Palo Verde Nuclear  
Generating Station

**Subject: Palo Verde Nuclear Generating Station (PVNGS)  
Unit 2, Docket No. STN 50-529  
Clarification of Responses to Request for Additional Information  
Regarding Steam Generator Replacement and Power Uprate License  
Amendment Request**

**Clarification of Responses to Request for Additional Information  
from the Reactor Systems Branch**

Figure 1  
100% Power CEAW ROPMs

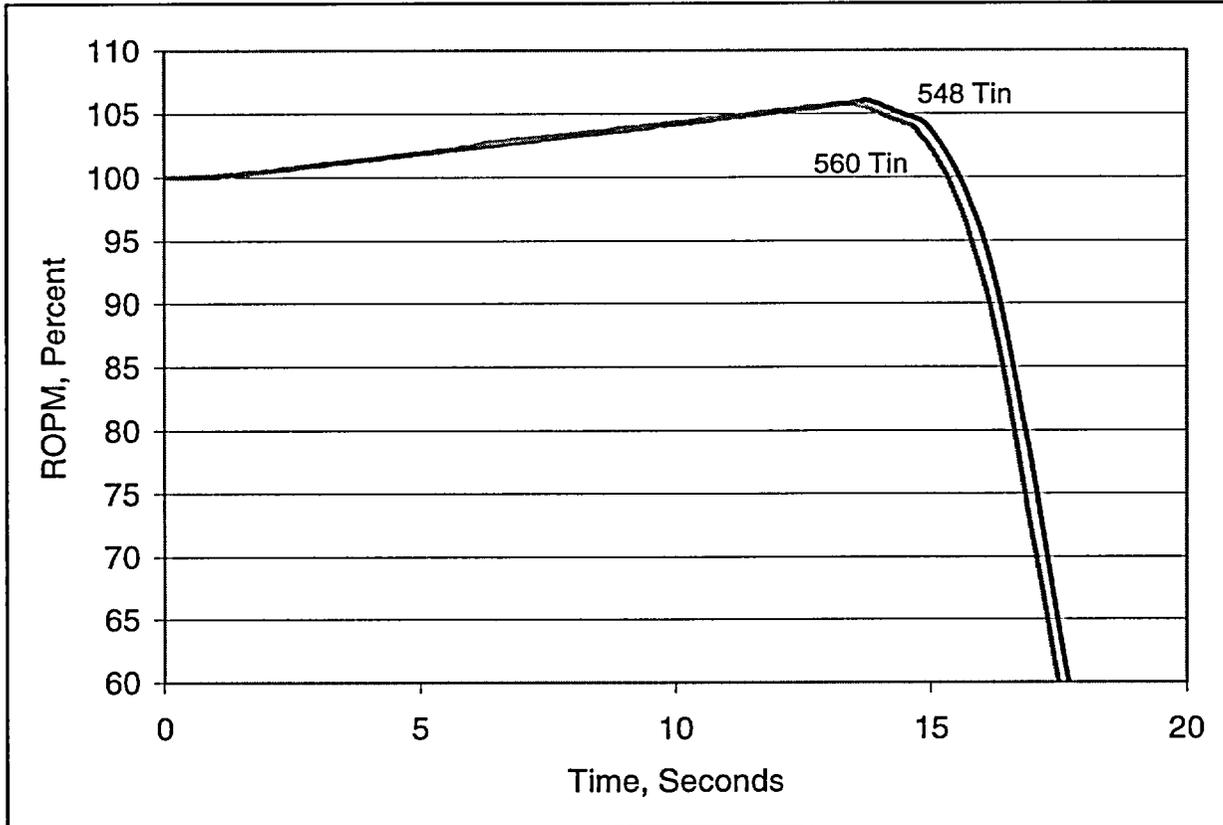
Question 27 of Reference [3] - Which Palo Verde Technical Specification ensures that the thermal margin assumed in the analyses is maintained? Has the licensee performed sensitivity studies to verify that a case starting from a higher initial core inlet temperature would result in a faster trip time, and thus, lower thermal degradation? If so, please provide results to demonstrate this.

The reactor trip responding to the withdrawal of the high worth CEA banks from high initial power conditions is the CPC Variable Overpower Trip (VOPT) function. The important inputs to VOPT are the neutron power signals and the change in, not initial value of, core inlet temperature. Figure 1 shows the ROPM resulting from initiating the event at 548 °F and 560 °F. As shown in the figure, the actual value of initial temperature does not affect the trip system as a result of the transient, and the ROPM is essentially unaffected by the selection of initial core inlet temperature.

Figure 1:  
MSLB HFP with LOP – RCS Pressure vs. Time (3876 MW<sub>t</sub>)

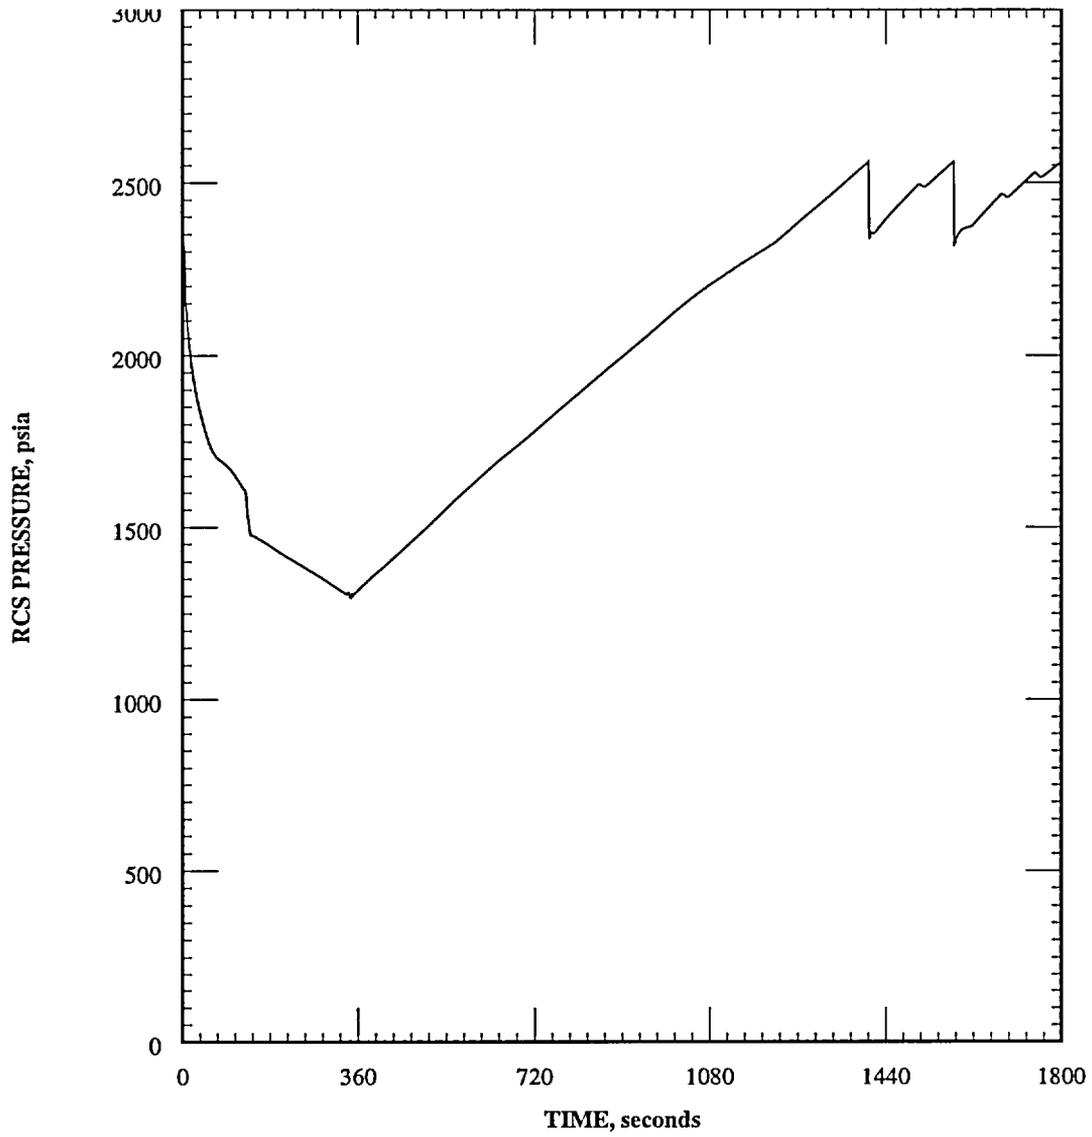
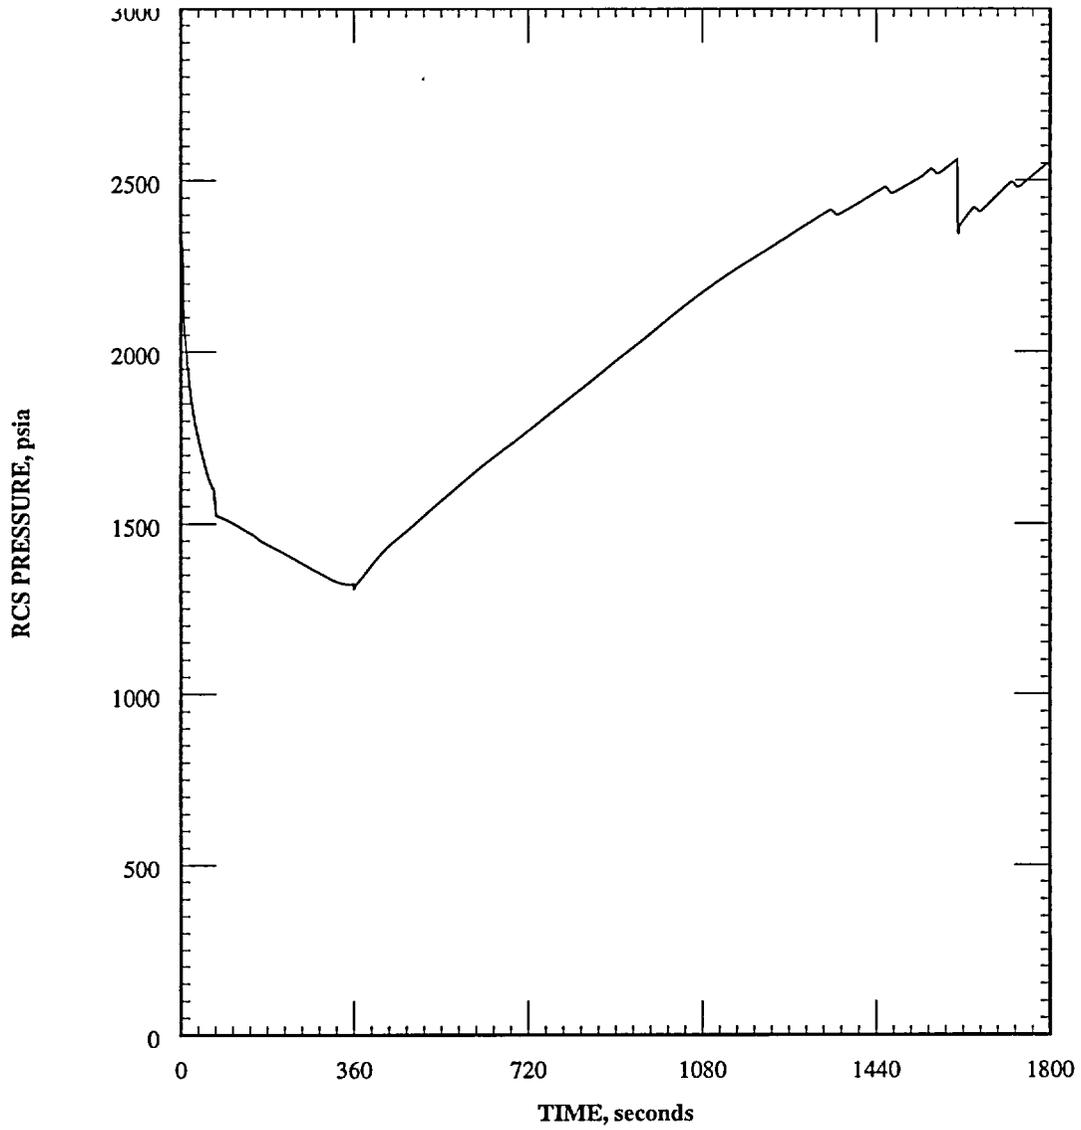
Figure 6.3-28, page 6-98 and 6-100. At the end of 10 minutes the pressure keeps rising yet you concluded that the pressure remains within the acceptance limits. How did you arrive in that conclusion, since the operator action is 20 minutes away?

The long-term NSSS response for the "increased heat removal by the secondary system" events is similar for each event in this category due to the same physical phenomena driving the transient. The initial decrease in the RCS pressure due to cooldown is reversed later in the transient due to the R-t-P and /or NSSS recovery from the excess heat removal. Thus, the long term RCS pressure response for MSLB event is similar to the IOSGADV+LOP event presented in PURLR Figures 6.3-13 through 6.3-25 and Table 6.3-8. Figure 6.3-18 illustrates the long-term RCS pressure response for the IOSGADV+LOP event and represents a typical response for any increased heat removal by the secondary system event. As demonstrated in this figure, the automatic plant response (i.e. opening of PSVs) limits the RCS pressure, and the safety limit (110% of the design pressure) is not exceeded. Extended plots of RCS pressure versus time for the 3876 MW<sub>t</sub> and 3990 MW<sub>t</sub> MSLB-HFP with LOP cases are provided on the following pages.

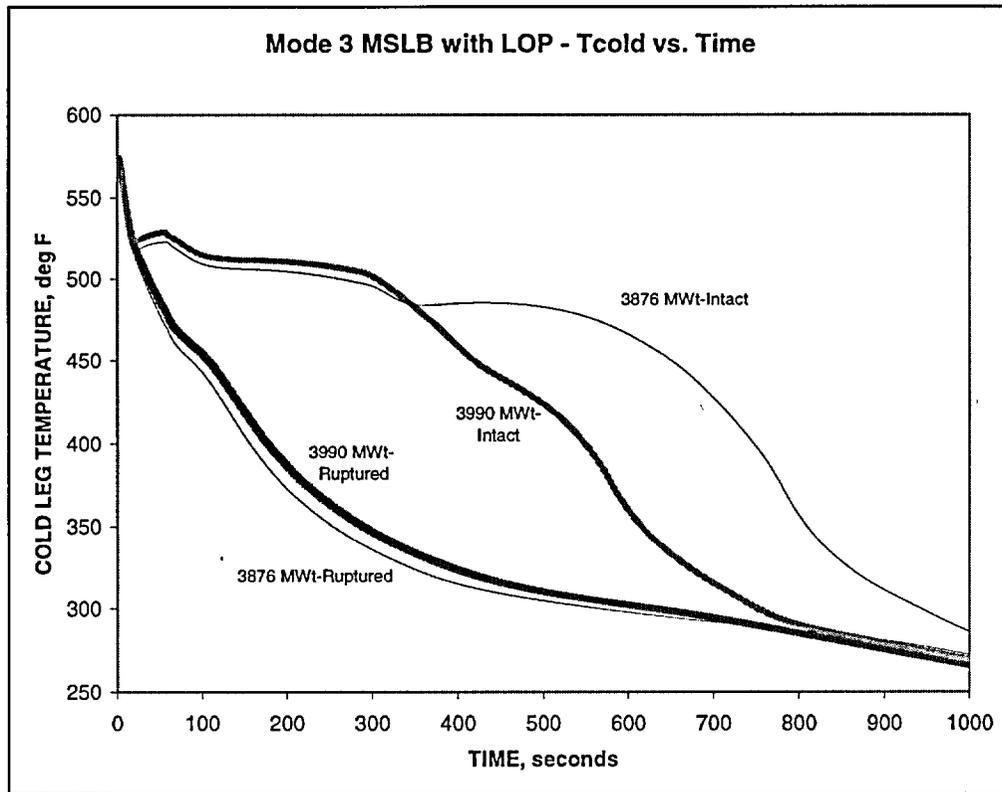
Figures 6-42/43/44. The intact steam generator displays a large discontinuity in behavior, yet there is nothing in the scenario to justify it. Please provide a physical explanation of these phenomena.

The PURLR Figures 6.3-42 thru 44 illustrate the behavior of the NSSS parameters during a Mode 3 MSLB event analysis used to demonstrate the adequacy of shutdown margin. The figures demonstrate that the positive reactivity insertion following the reactor trip results in a period of power increase, which is later compensated by the shutdown margin provided.

The discontinuity in Figure 6.3-42 occurring at approximately 10 seconds into the transient is due to the isolation of the SGs upon receipt of the Main Steam Isolation Signal (MSIS). The Mode 3 MSLB analysis for the 3876 MW<sub>t</sub> case receives a MSIS at a steam pressure setpoint of 810 psia, while the 3990 MW<sub>t</sub> case receives a MSIS at 875 psia (see Attachment 3 of Reference 1 for proposed Technical Specification changes). The lower SG pressure of the 3876 MW<sub>t</sub> case results in moderator temperatures that are lower during the initial phases of the transient. The difference in R-t-P between the two cases as a result of the cold leg temperature differences is shown in PURLR Figure 6.3-42. For both cases, the difference in cold leg temperatures disappears once subcriticality is reestablished via the start of the safety injection system. The response of the cold leg temperatures on a longer simulation of the event is shown below:
